Economic and Social Council

World Forum for Harmonization of Vehicle Regulations

Working Party on Lighting and Light-Signalling

Report of the Working Party on Lighting and Light-Signalling on its sixty-fifth session

Figure 1
Category D8S - Cap PK32d-1

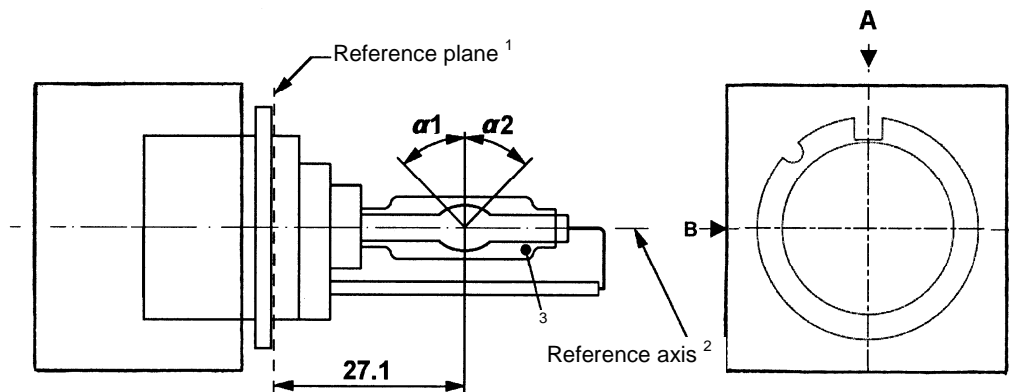
Insert new sheets D8S/1 to 5 after D6S/5, to read:

Sheet D8S/1
